Falcon Highlands

Final Drainage Report

Provide PCD file No.
SF2418

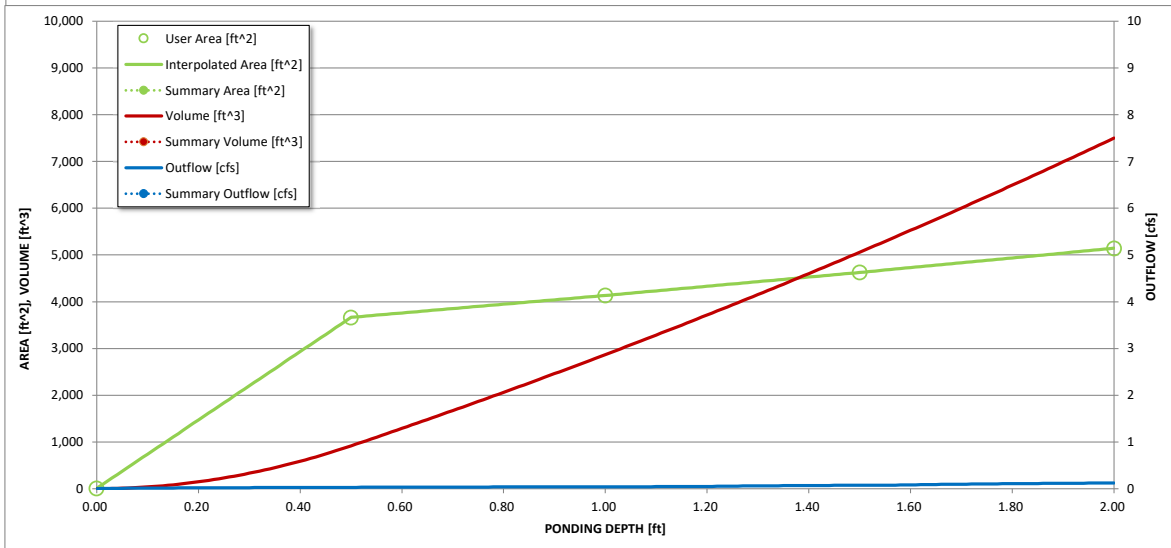
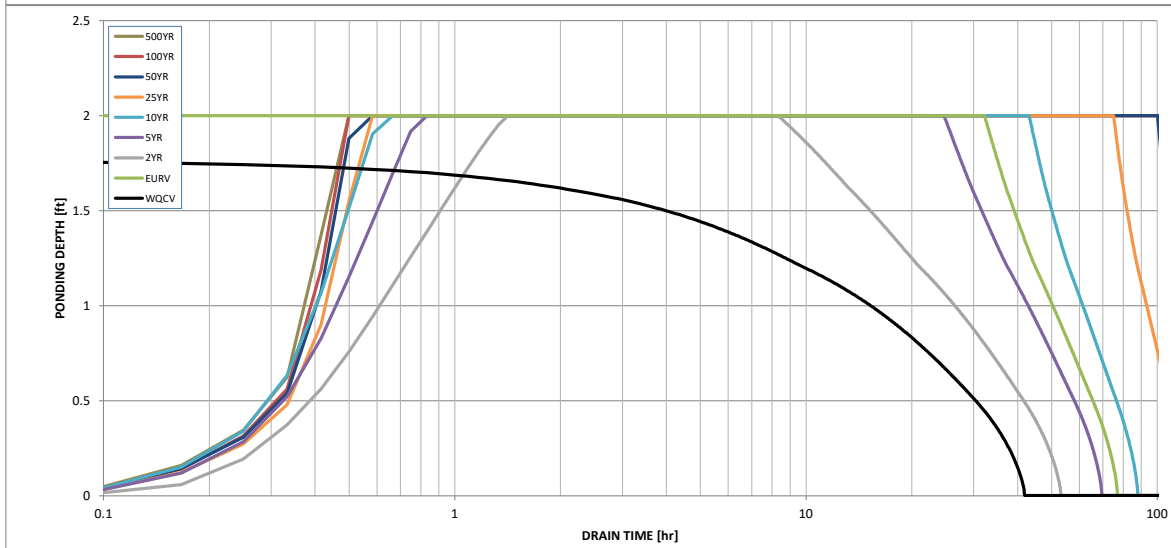
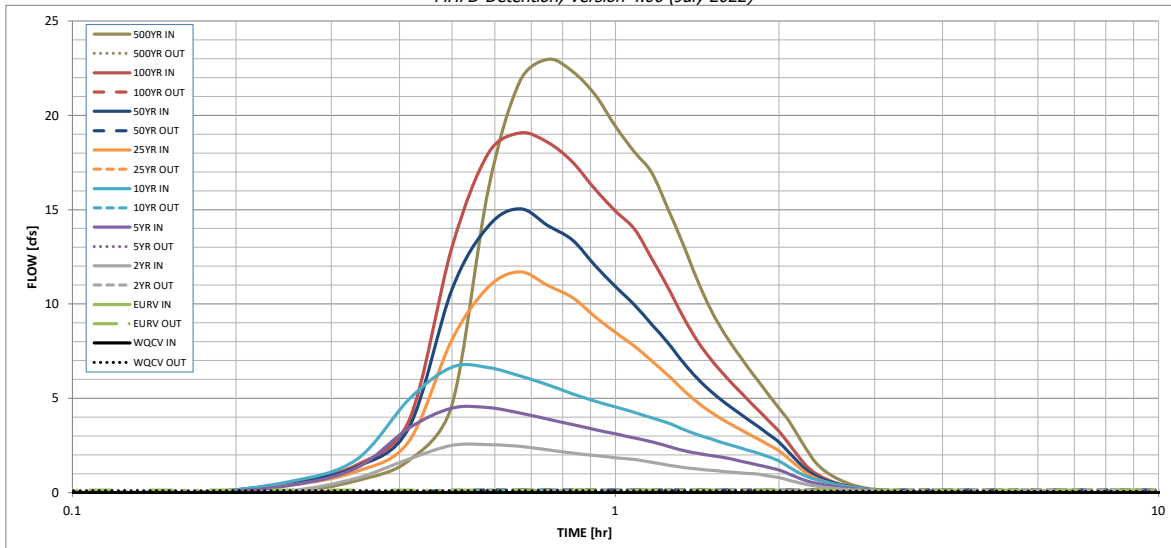
The project has an outlet pipe, it is a unique design but I believe this section should be filled out.

Even temporary ponds need spillways.

see note 1

Trapezoidal

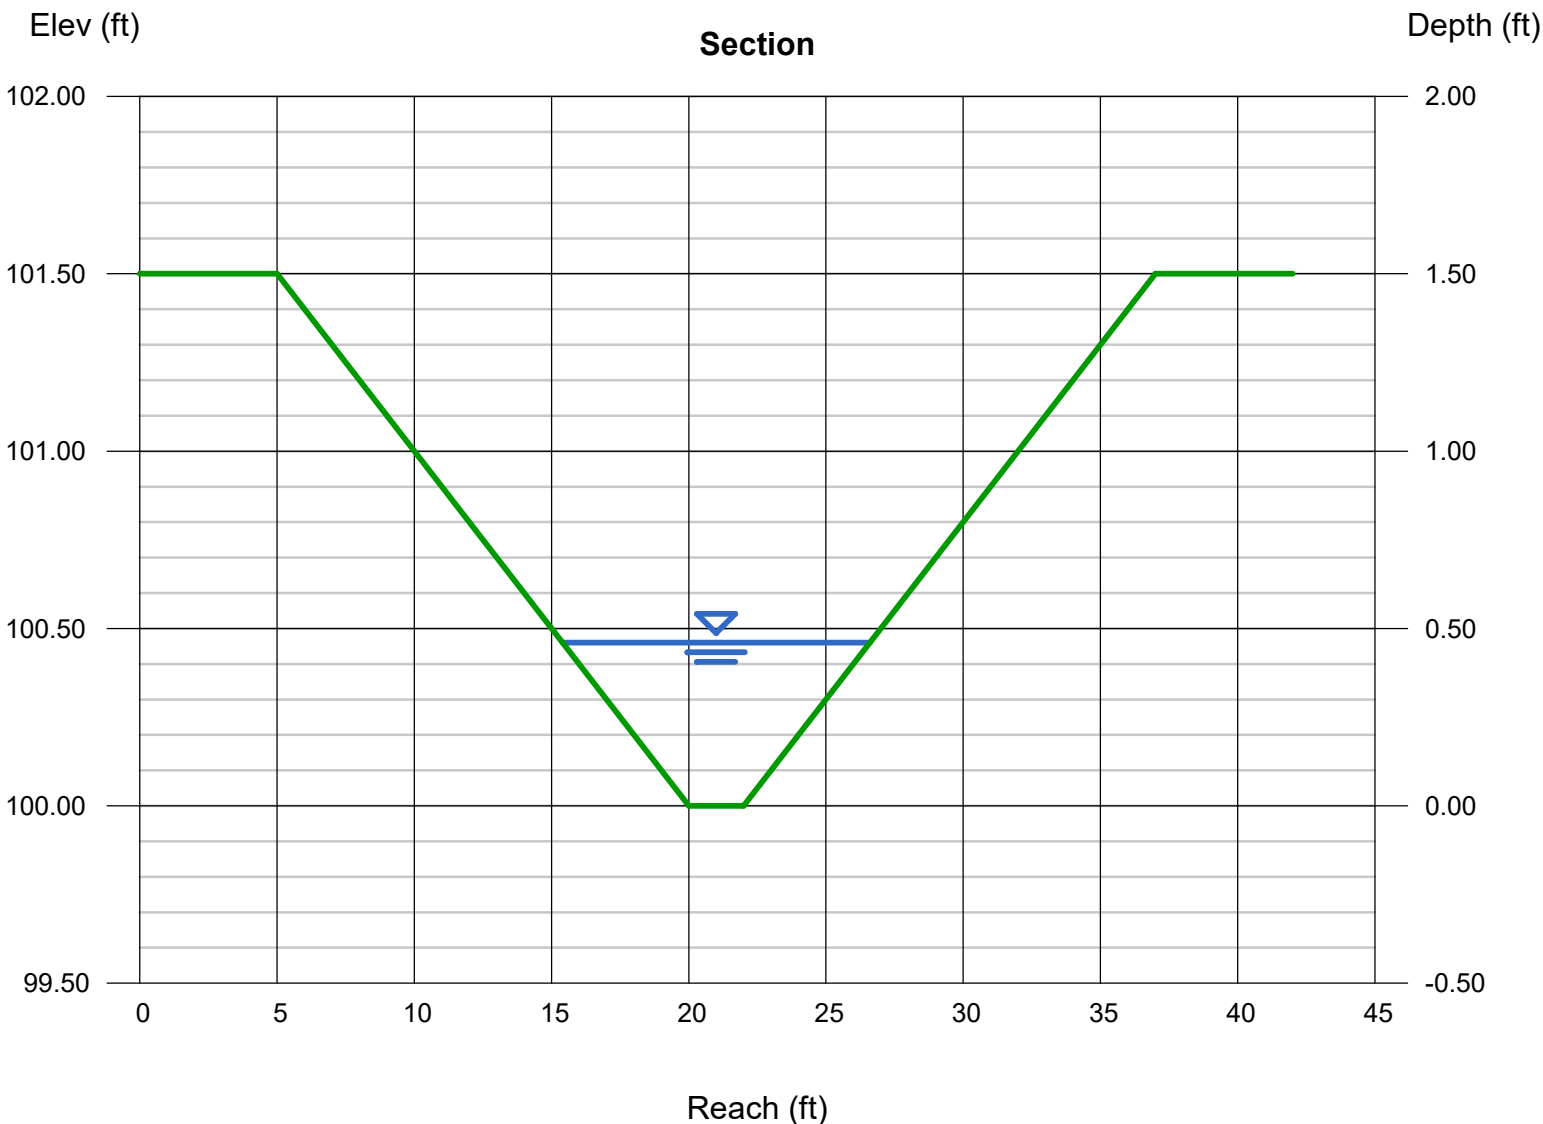
Provide name for ditch so it is clear where this analysis applies and what storm the analysis is for.

updated

Trapezoidal

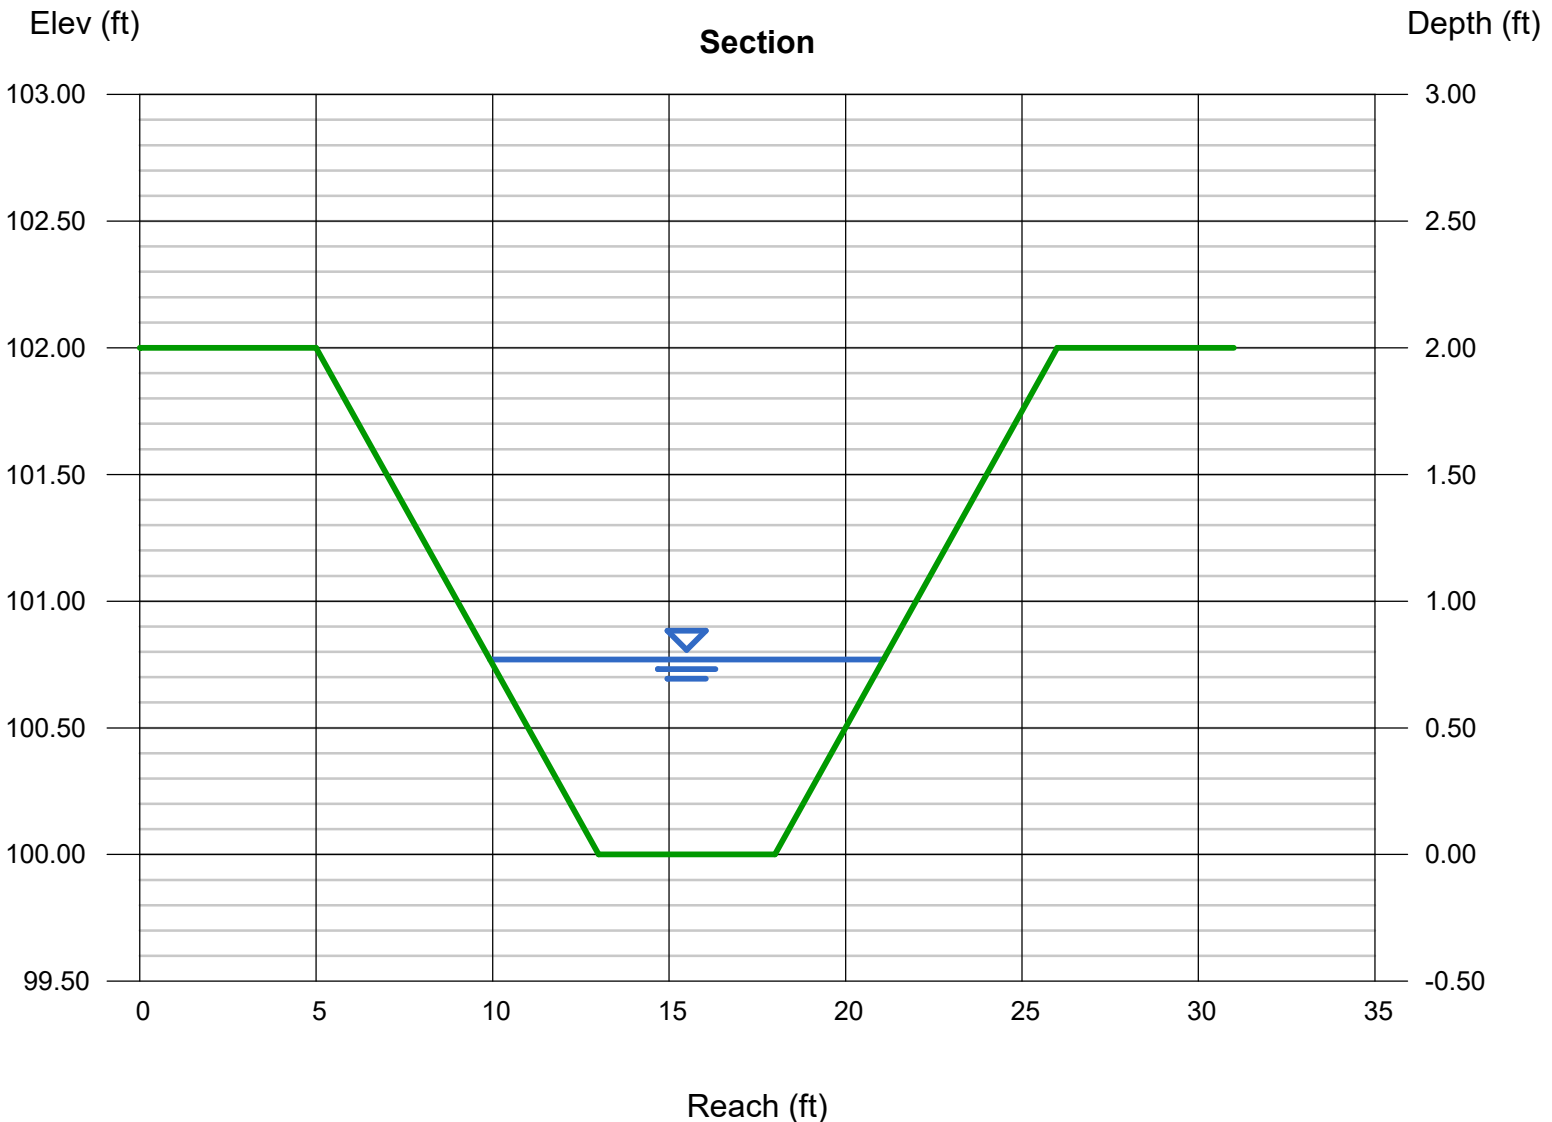
Provide name for ditch so it is clear where this analysis applies and what storm the analysis is for.

swale removed, see note 1

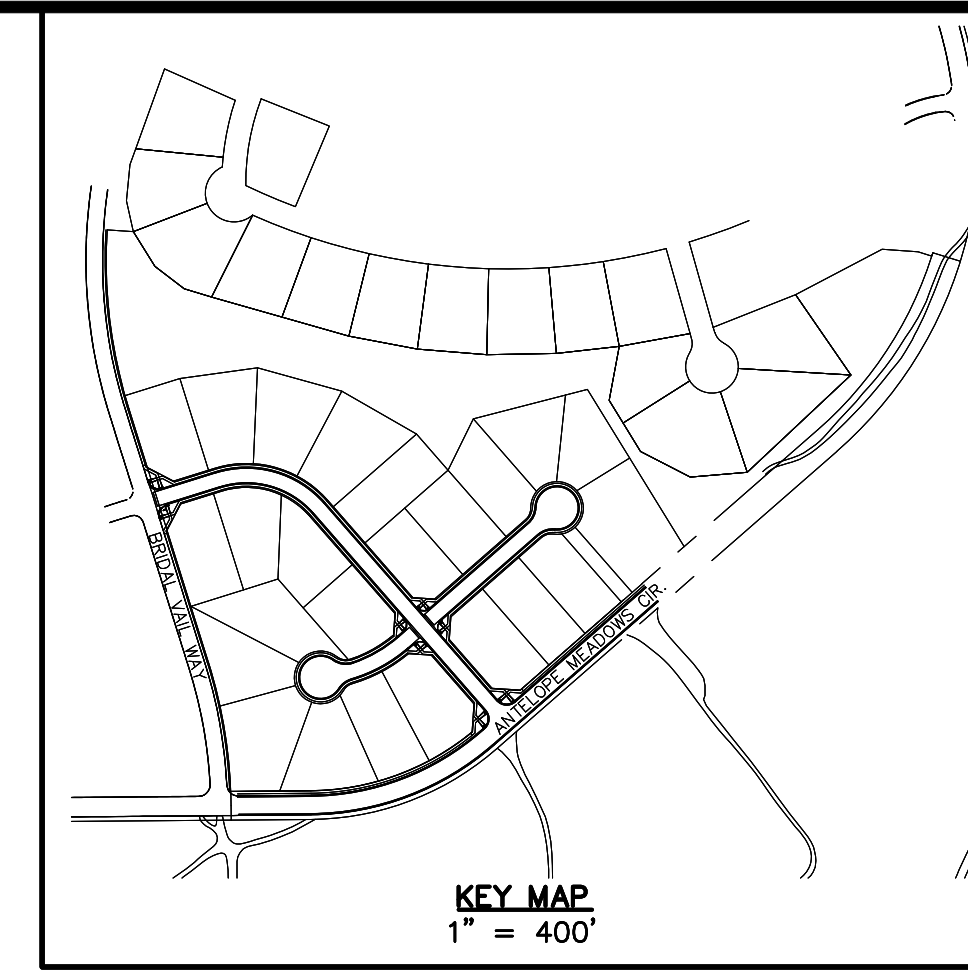
Please create a basic overview map (or modify an existing drainage map) with color shading/hatching that shows areas tributary to each PBMP (pond, runoff reduction, etc.) and those disturbed areas that are not treated by a PBMP, with the applicable exclusion labeled (ex: 20% up to 1ac of development can be excluded per ECM App I.7.1.C.1 and exclusions listed in ECM App I.7.1.B.#). An accompanying summary table on this map would also be very helpful (example provided):

table and map added

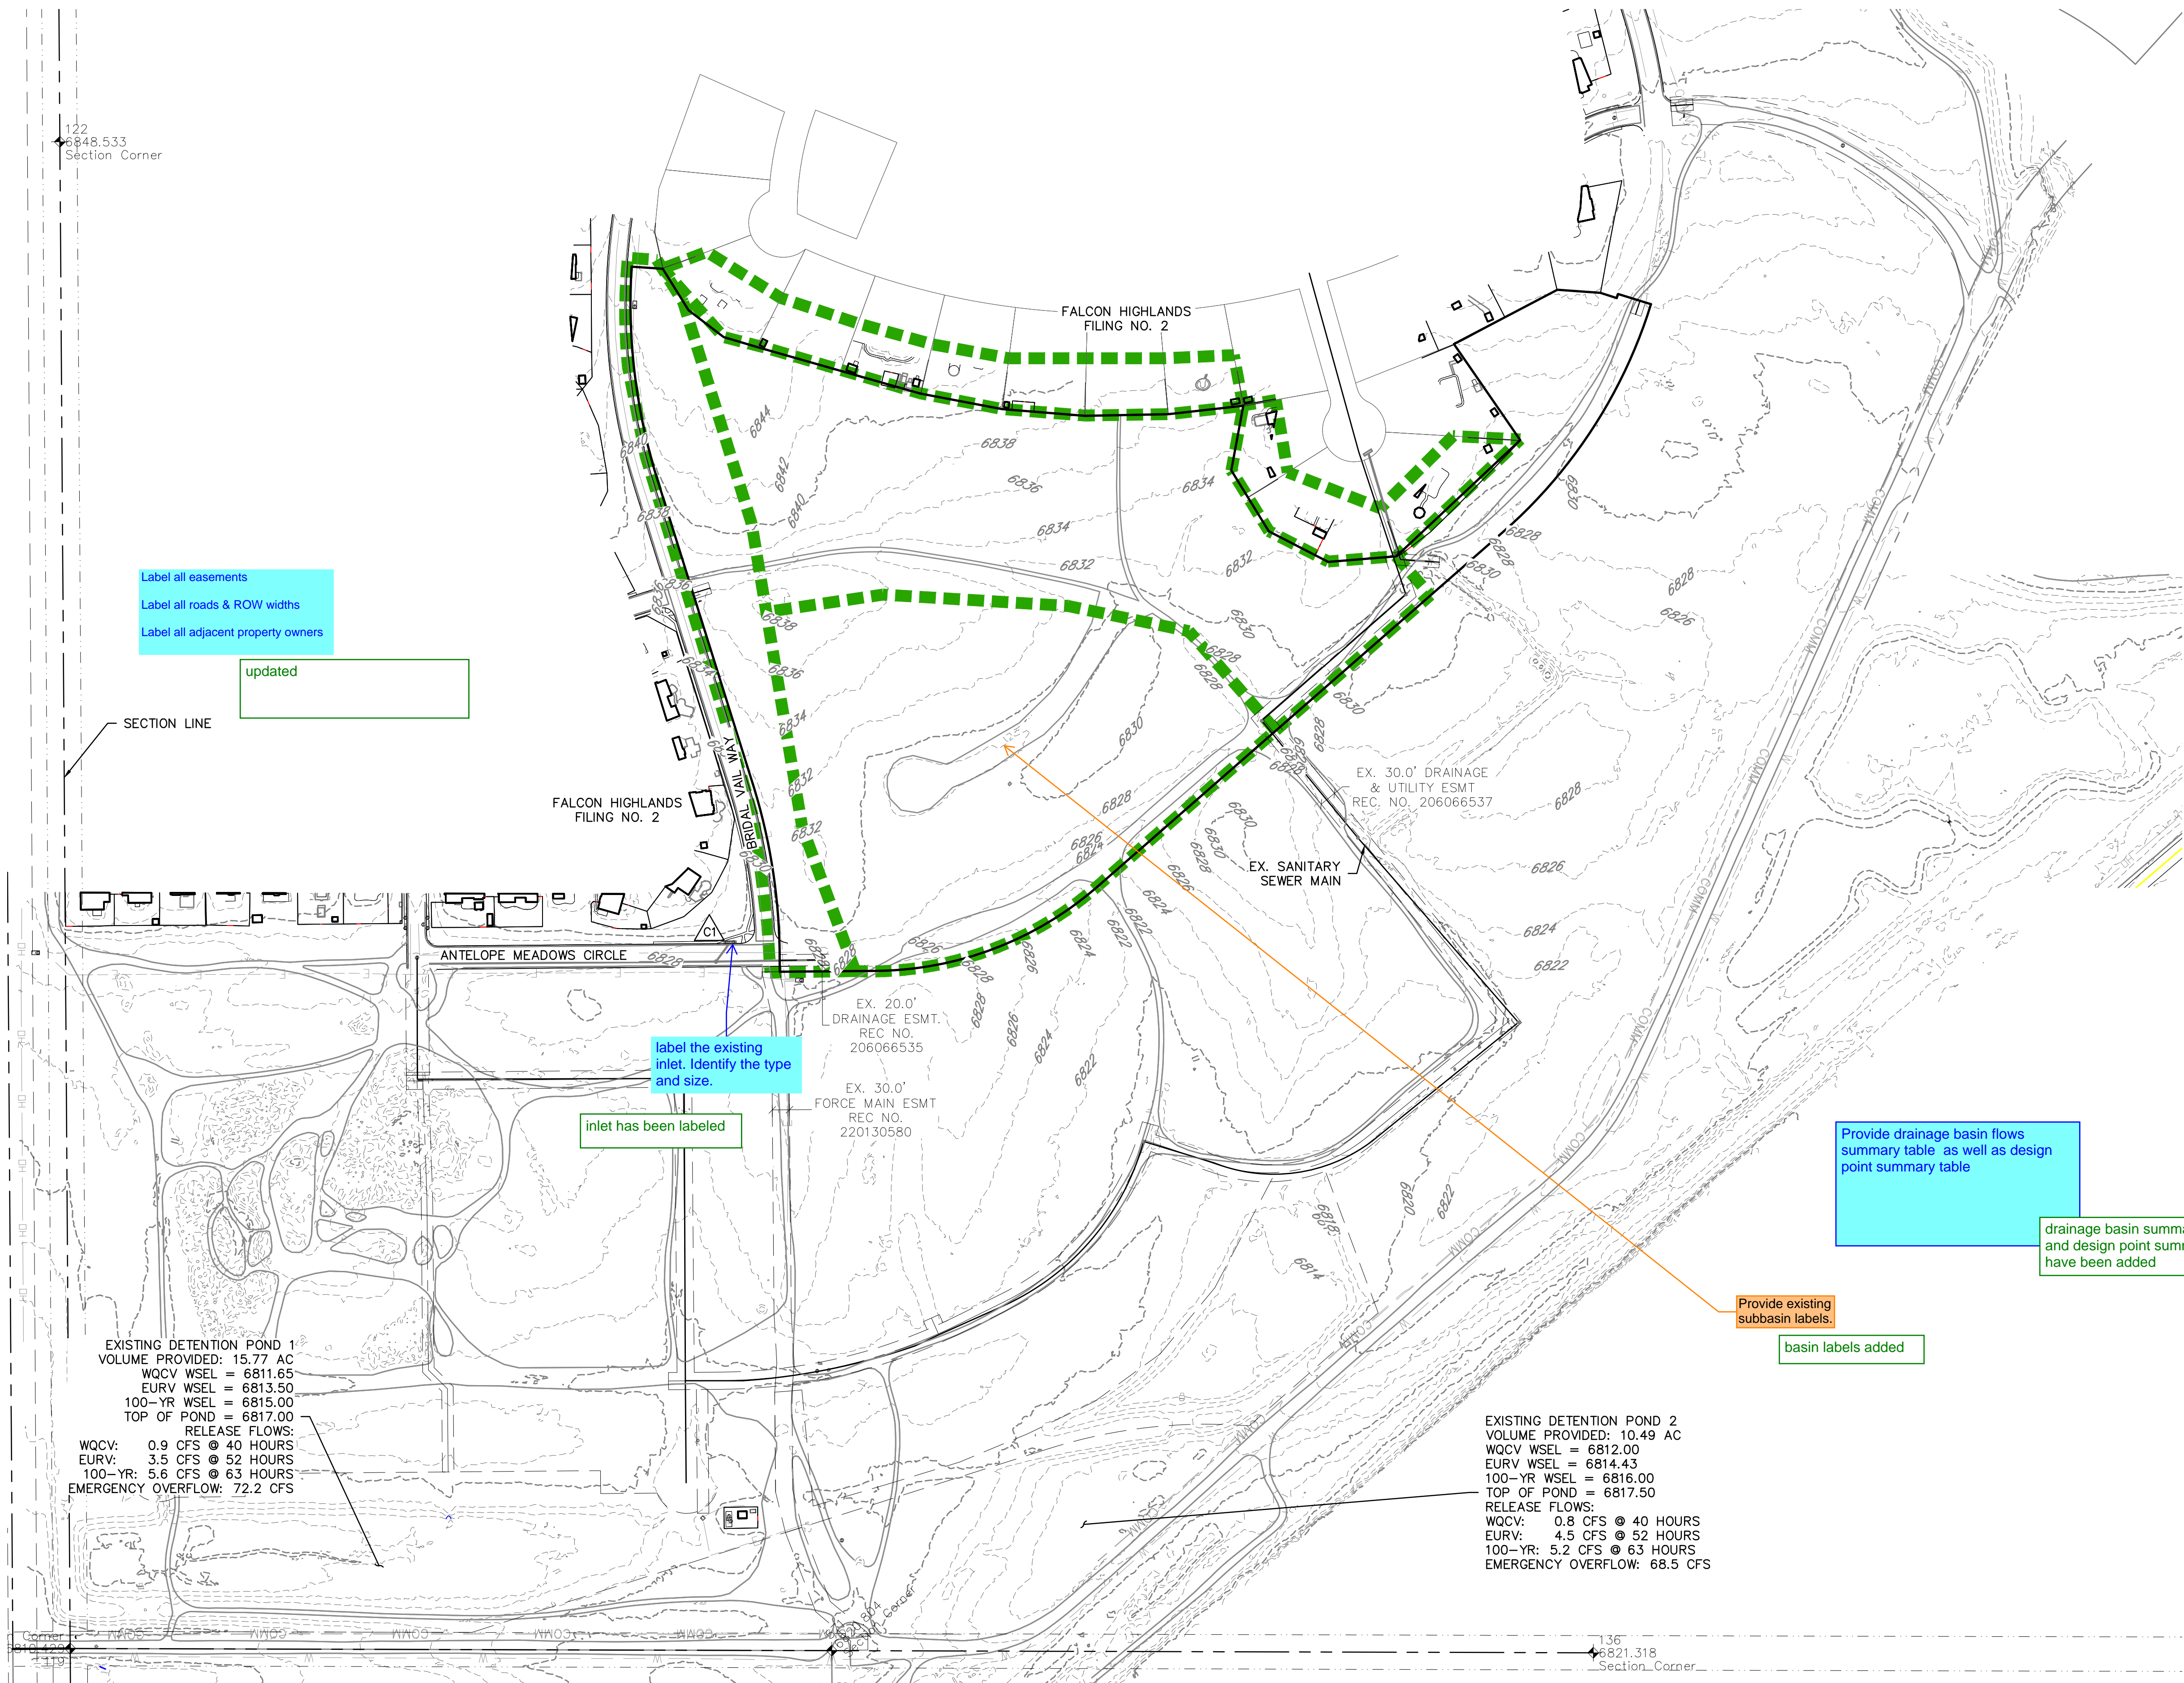
label the existing inlet. Identify the type and size.
inlet has been labeled

Provide drainage basin flows summary table as well as design point summary table
drainage basin summary and design point summary have been added

EXISTING DETENTION POND 1
VOLUME PROVIDED: 15.77 AC
WQCV WSEL = 6811.65
EURV WSEL = 6813.50
100-YR WSEL = 6815.00
TOP OF POND = 6817.00
RELEASE FLOWS:
WQCV: 0.9 CFS @ 40 HOURS
EURV: 3.5 CFS @ 52 HOURS
100-YR: 5.6 CFS @ 63 HOURS
EMERGENCY OVERFLOW: 72.2 CFS

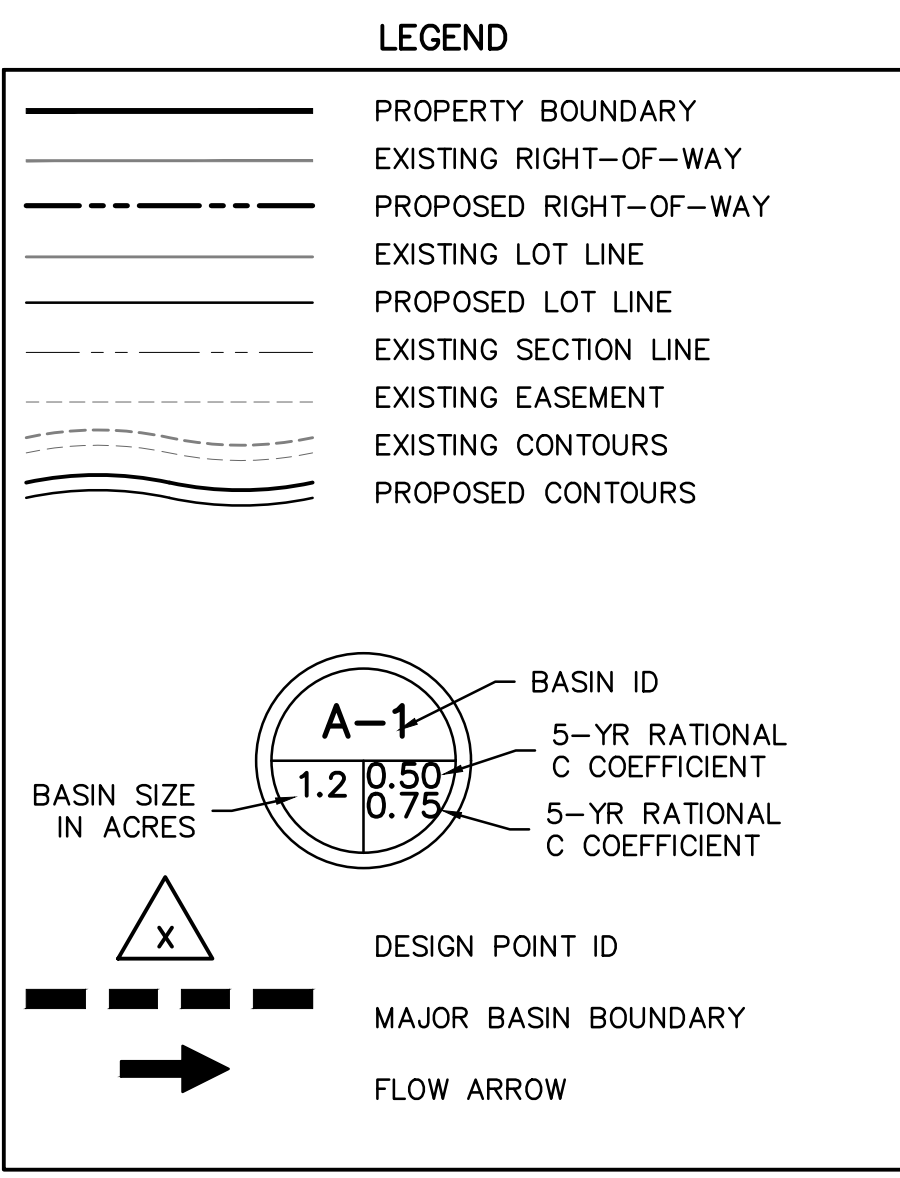
Provide existing subbasin labels.
basin labels added
